Re: VCP # 16CVCP002Q
E-Designation # 15EHAN396Q
31-07 38th Avenue
Remedial Action Work Plan (RAWP) Stipulation List

Athenica Environmental hereby submits a Remedial Action Plan (RAWP) Stipulation List for the Site to the New York City Office of Environmental Remediation (OER) on behalf of Kayafas Contracting Company. This letter serves as an addendum to the RAWP to stipulate additional content, requirements, and procedures that will be followed during the site remediation. The contents of this list are added to the RAWP and will supersede the content in the RAWP where there is a conflict in purpose or intent. The additional requirements/procedures include the following Stipulation List below:

PROPOSED SSDS
 SUBSLAB DEPRESSURIZATION SYSTEM

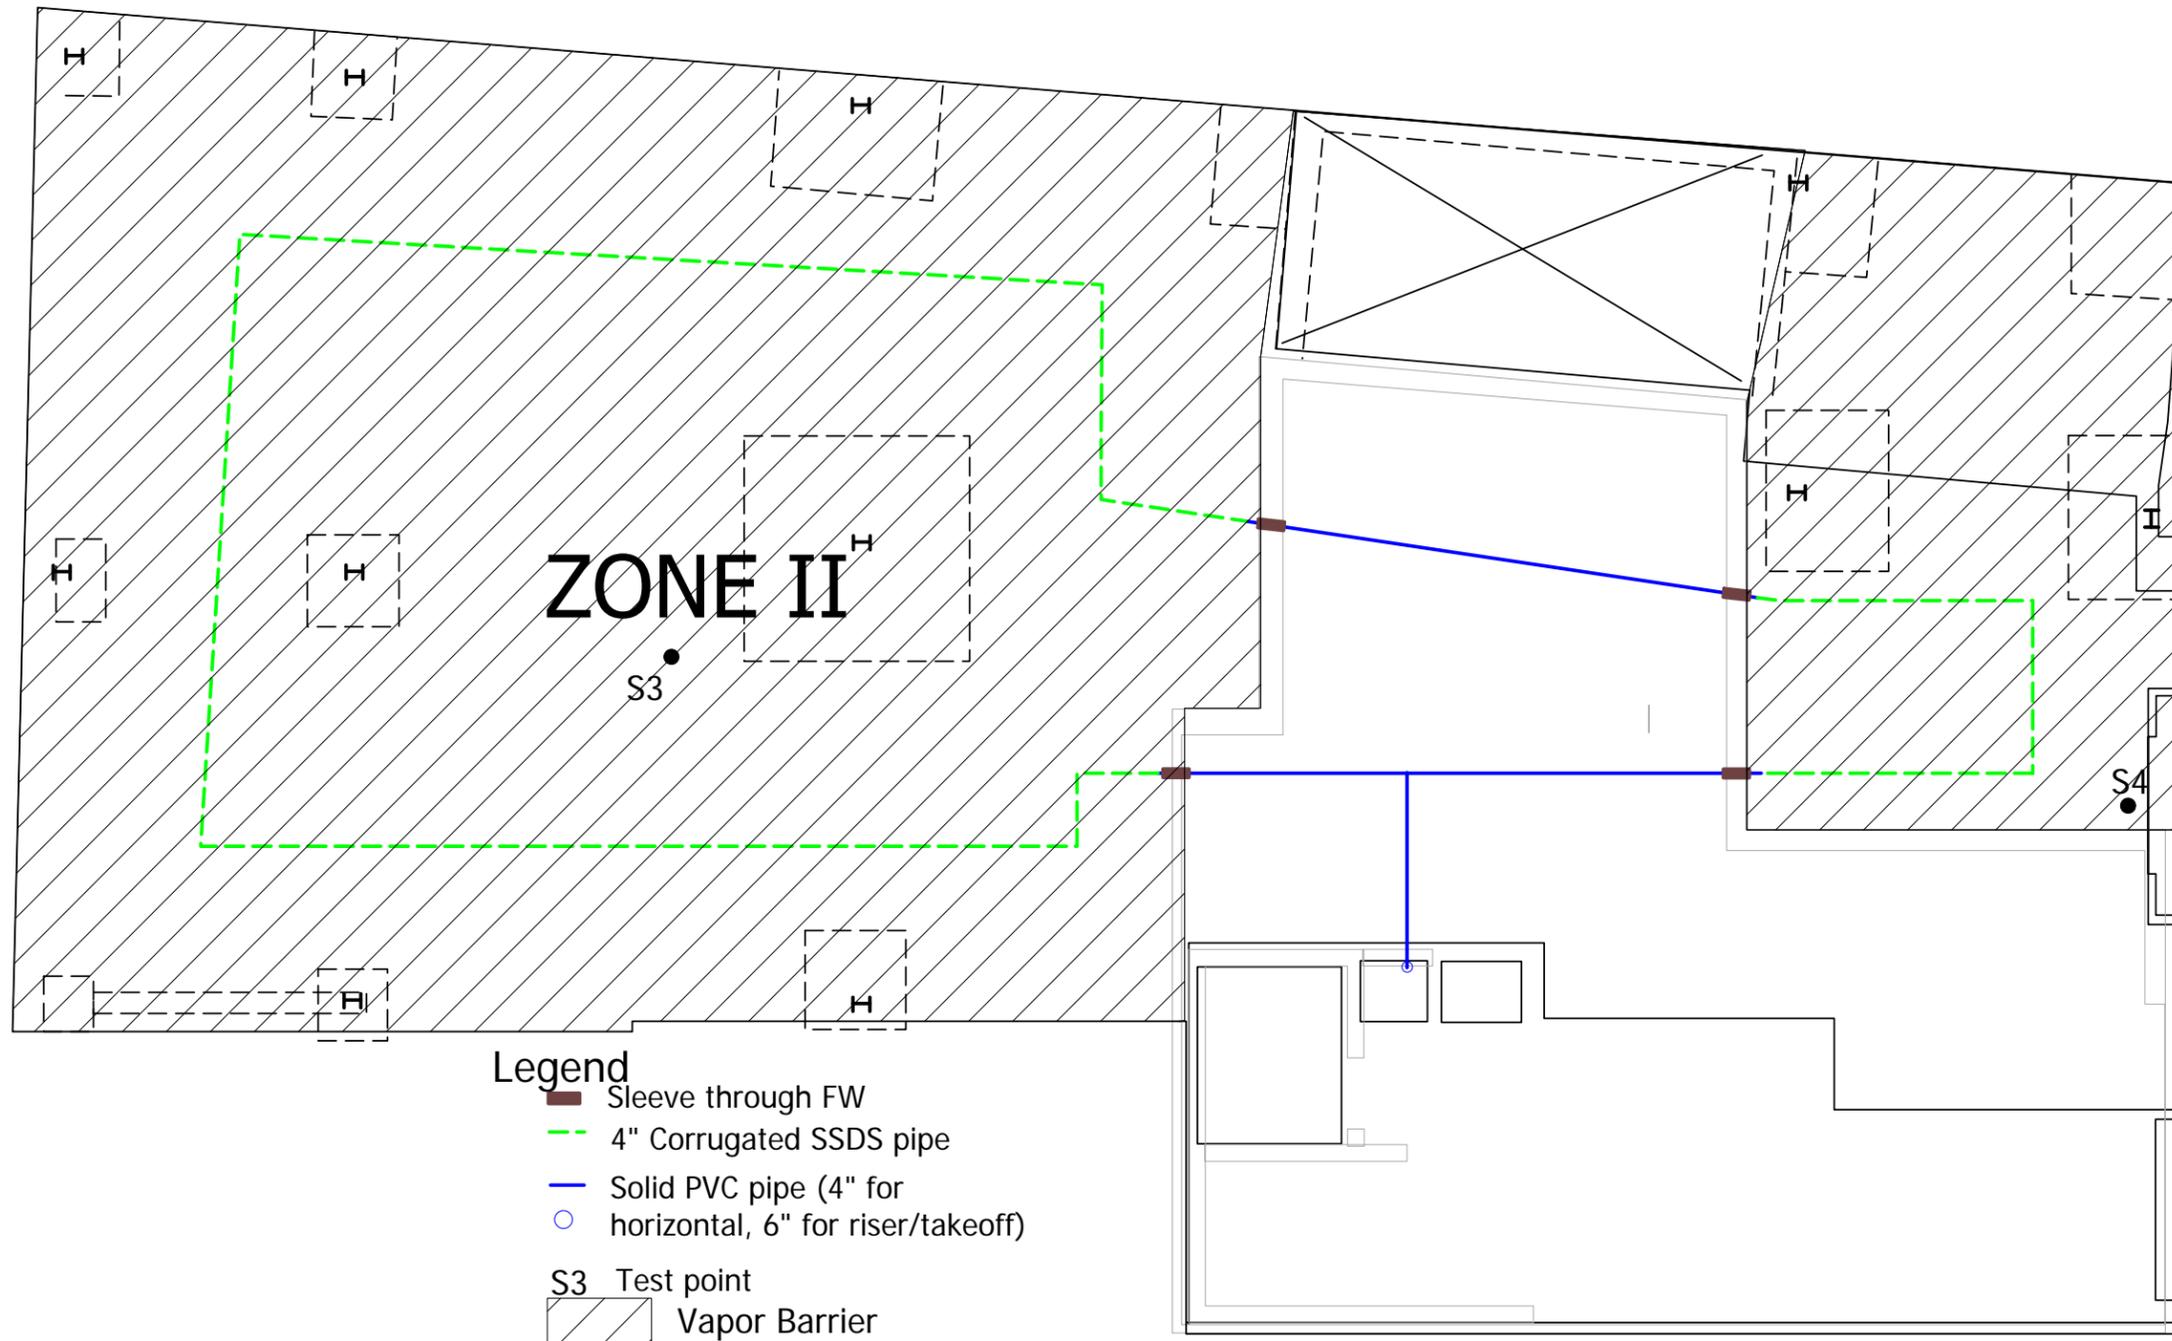
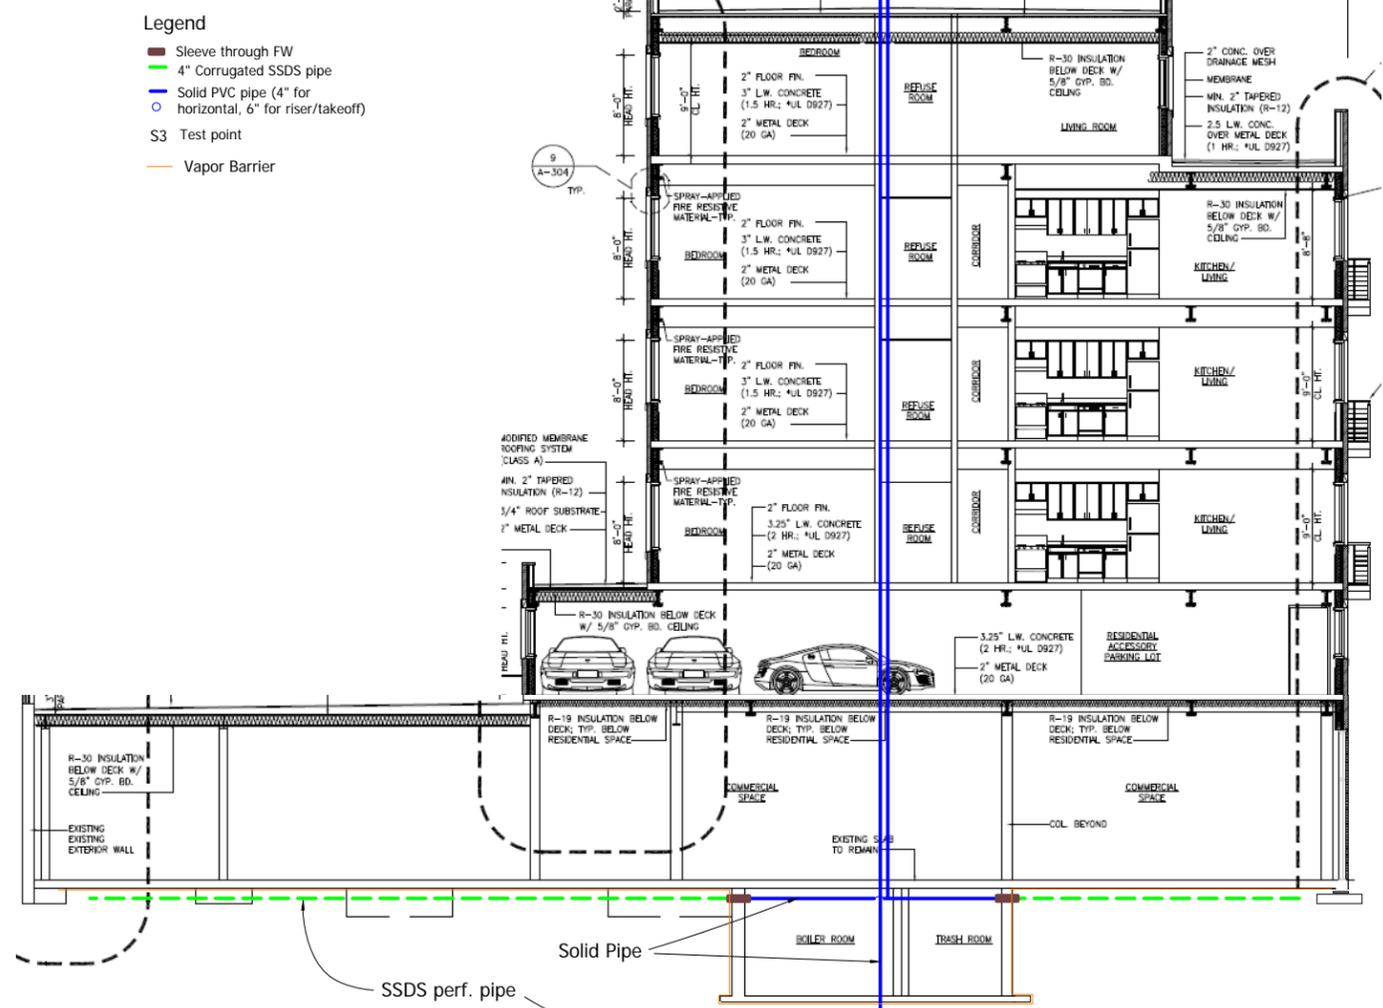
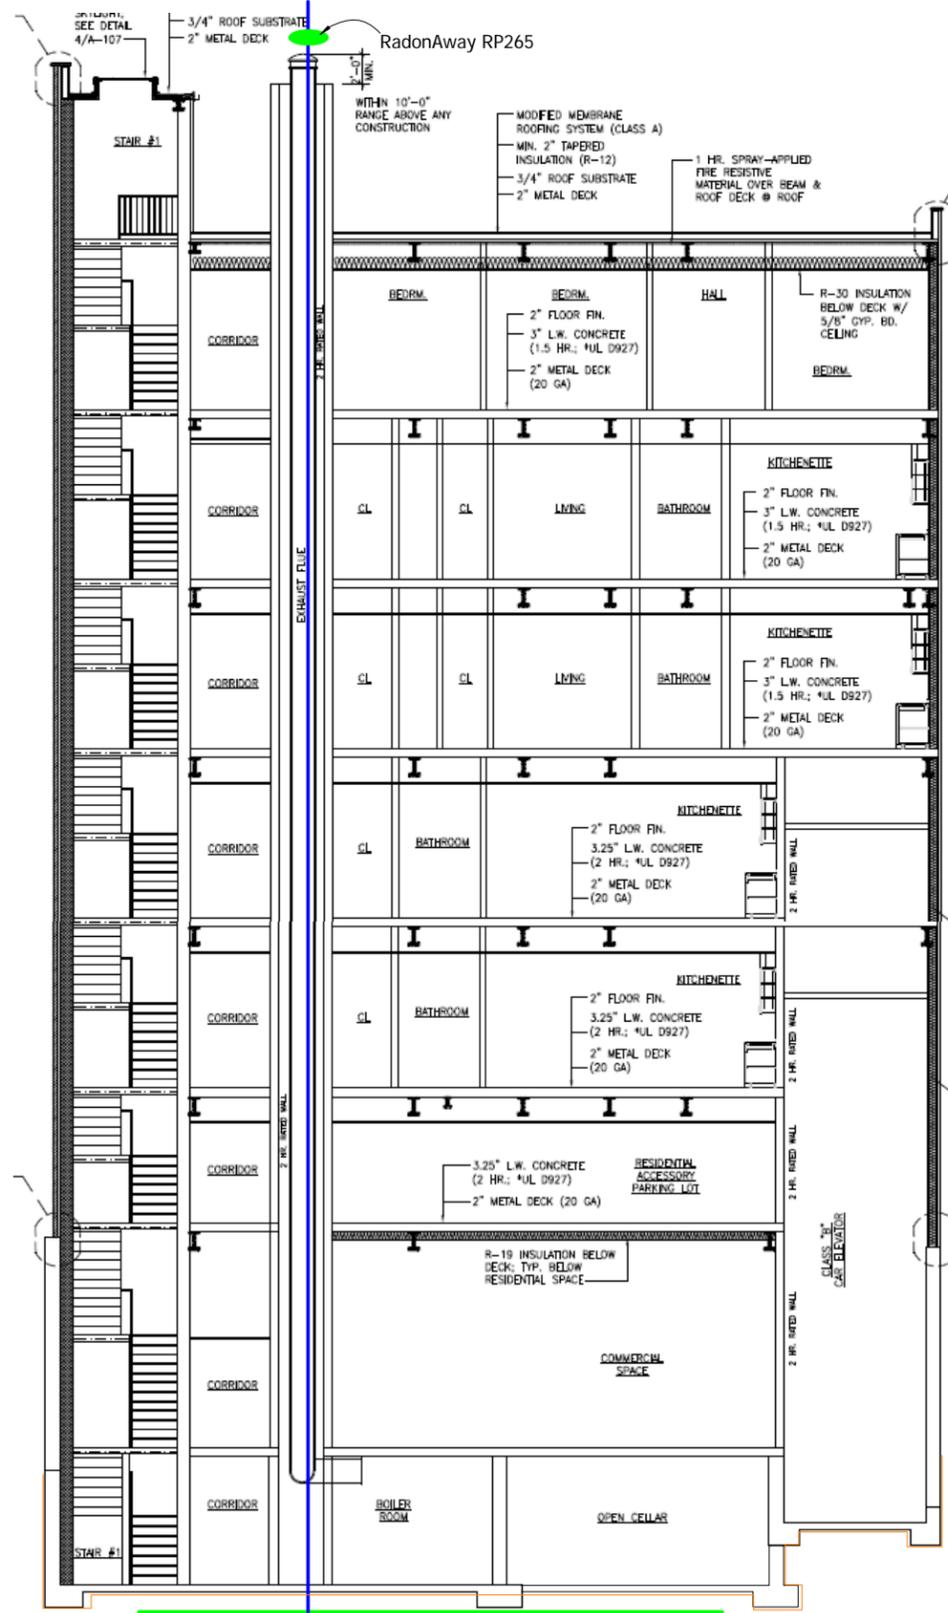
11. Installation of an active sub-slab depressurization system (SSDS) consisting of two closed loops of horizontal piping set in the middle of a gas permeable aggregate layer immediately beneath the vapor barrier system, which is under the basement slab (Zone I) and under the first floor slab (Zone II). Each loop will consist of fabric wrapped, perforated 4" Schedule 40 PVC pipe connected to a 6" inch cast iron riser that penetrates the slab and travels through the building to the roof. Additionally, a total of four testing points will be installed in the basement slab and the first floor slab to measure the effectiveness of the SSDS. Specifications for the active sub-slab depressurization system, testing points, and equipment specifications are found in **Appendix 10**.

1. REFER TO ARCHITECTURAL PLANS FOR WATERPROOFING REQUIREMENTS.
2. FOUNDATION WALL BELOW GRADE SHALL BE PROTECTION WITH VAPOR BARRIER.
3. PROTECT ELEVATOR PIT WITH VAPOR BARRIER: BOTTOM OF SLAB AND OUTSIDE WALLS.

4. FAN TO BE RADONAWAY HIGH FLOW INLINE FAN, MODEL RP-265 OR APPROVED EQUAL.
5. FAN AND ON/OFF SWITCH TO BE HARD-WIRED TOGETHER TO 115 VOLT CIRCUIT.
6. SECURE RUBBER COUPLING WITH SCREW TO PREVENT FAN ASSEMBLY FROM SLIPPING DOWN VERTICAL PIPE.

7. DWYER MAGNAHELIC DIAL TYPE VACUUM GAUGE MODEL 2002-M OR APPROVED EQUAL.
8. ABOVE SLAB RISER MUST BE CAST IRON OR PVC SCH 40. IF PVC, THEN ENCLOSE PIPE WITH ENCLOSURE OF THE SAME FIRE RATING AS THE SPACE OCCUPANCY.

9. USE 4" SOLID PVC SCHEDULE 40 PIPE. GLUE ALL CONNECTIONS.
10. VAPOR BARRIER TO BE VAPORBLOCK VBP20 FROM RAVEN INDUSTRIES OR EQUAL.
11. PROGRESS INSPECTIONS:
